LiDAR Quality Assessment Report

CA_PlacerCo_2012

FEMA IX - Placer County CA LiDAR

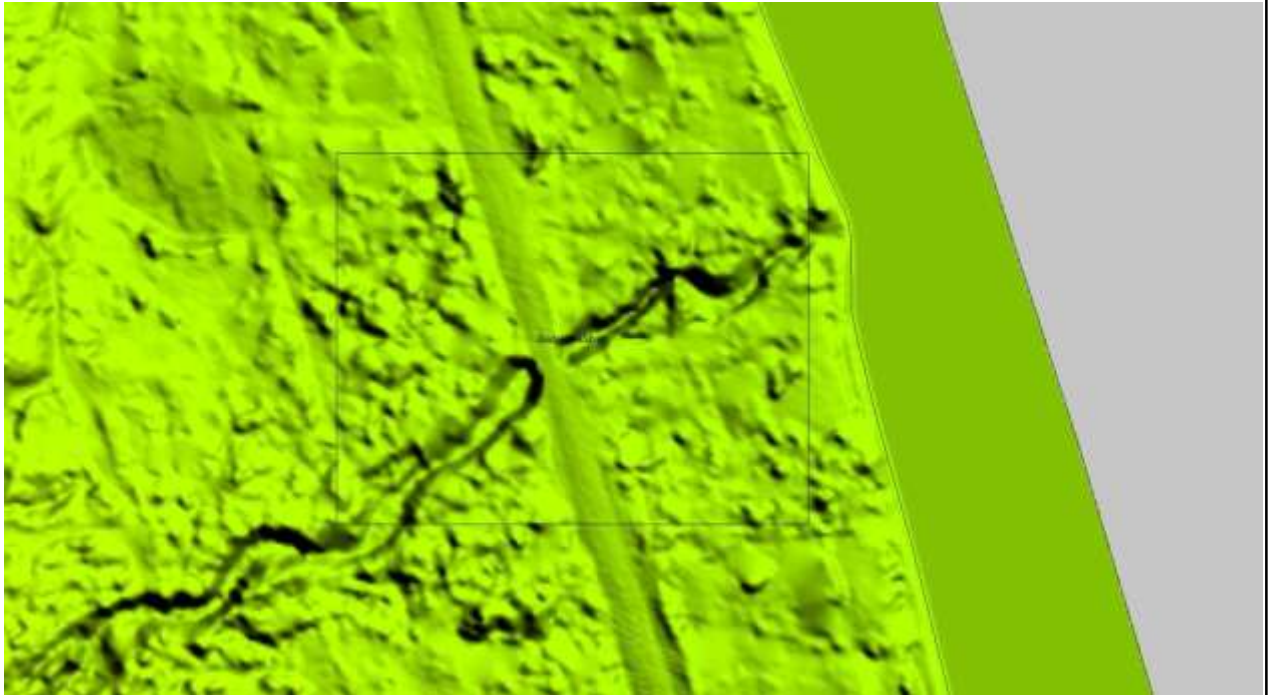
A few Areas where it was difficult to determine if a feature was a Culvert or Bridge. Dewberry states in their delivery report: "Culverts and Bridges: Bridges have been removed from the bare earth surface while culverts remain in the bare earth surface. In instances where it is difficult to determine if the feature is a culvert or bridge, such as with some small bridges, Dewberry erred on assuming they would be culverts especially if they are on secondary or tertiary roads".

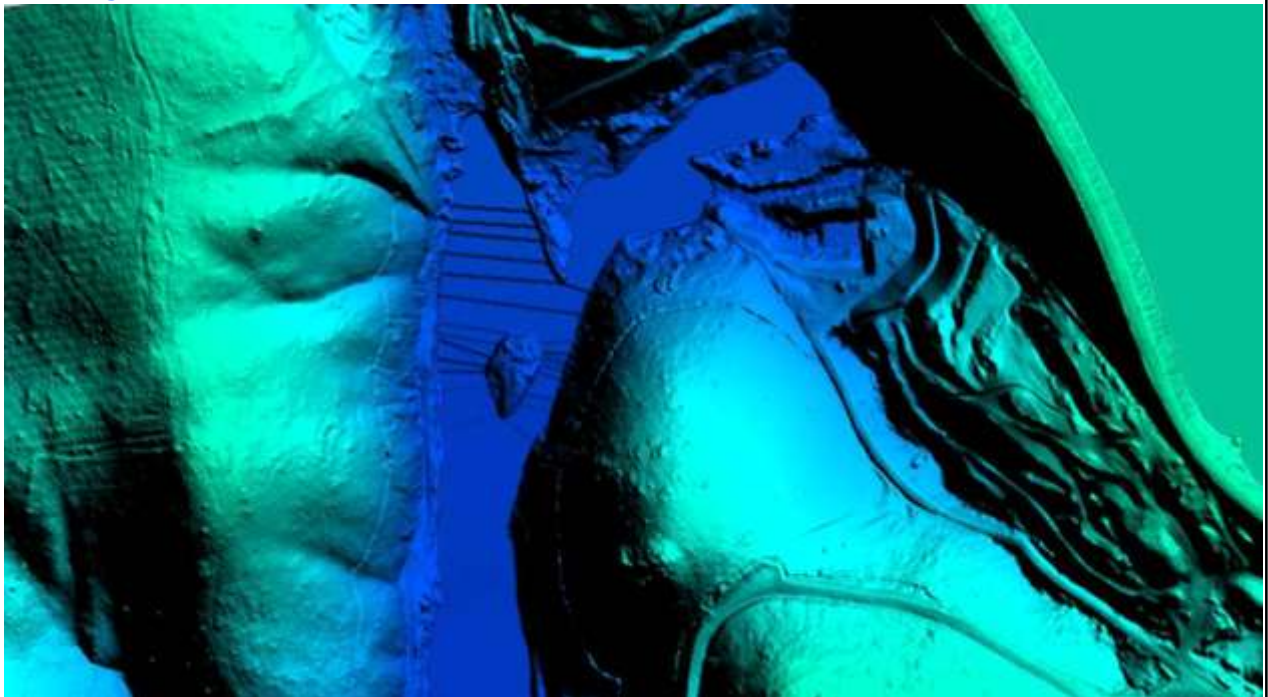
In the Western DEMs river elevation is flattened in a stair step manner, water flows downhill correctly. This is noted in the delivery report.

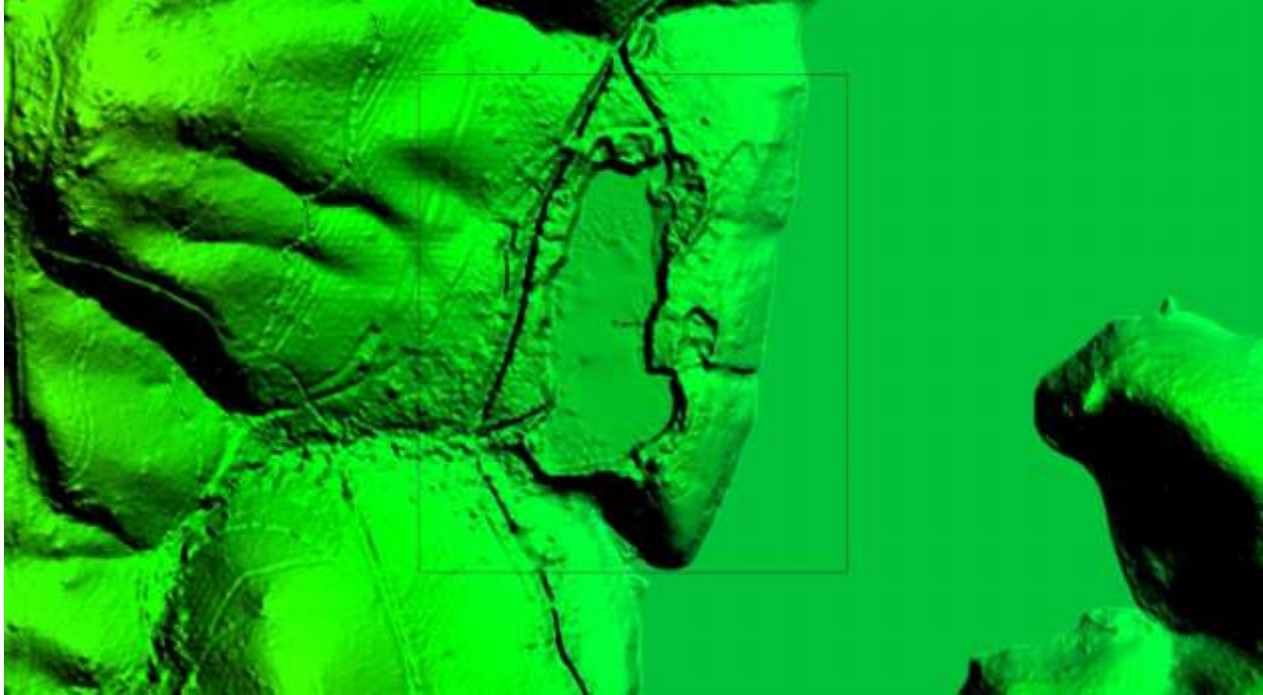
A couple waterbody flattening calls, the majority of 2 Acre or greater water is well flattened.

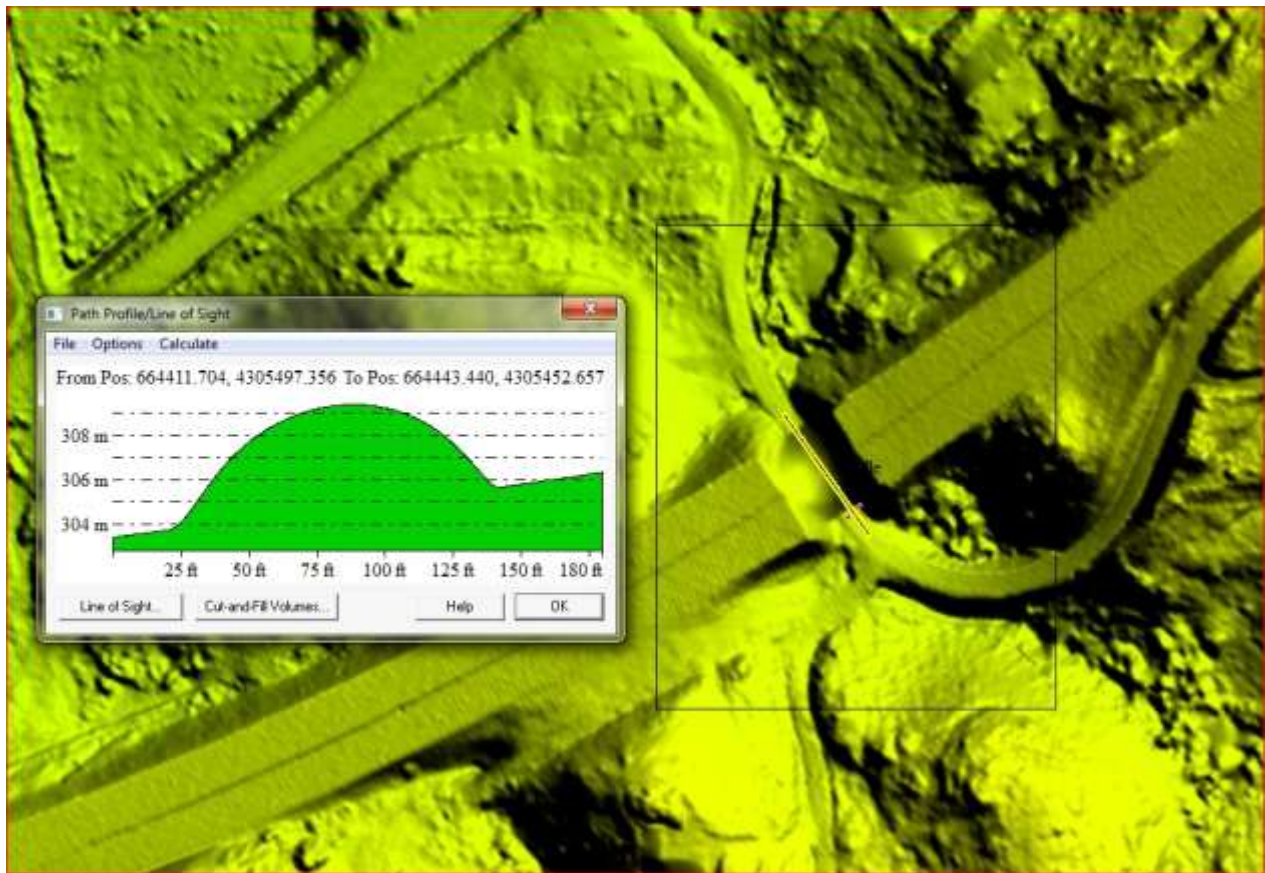
When viewed and profiled in a hillshade several bridge removal areas exhibit a "saddle" artifact. Dewberry states that "Because a continuous surface is being created, the TIN or Terrain will use interpolation to triangulate across a bridge opening from legitimate ground points on either side of the actual bridge. This can cause visual artifacts or "saddles." These "artifacts" are only visual and do not exist in the LiDAR points or breaklines". (see page 26 of the Dewberry Project Report for more information). While the point cloud classification is correct, the use of breaklines or raster techniques could have been used to create a more level area under the bridge.
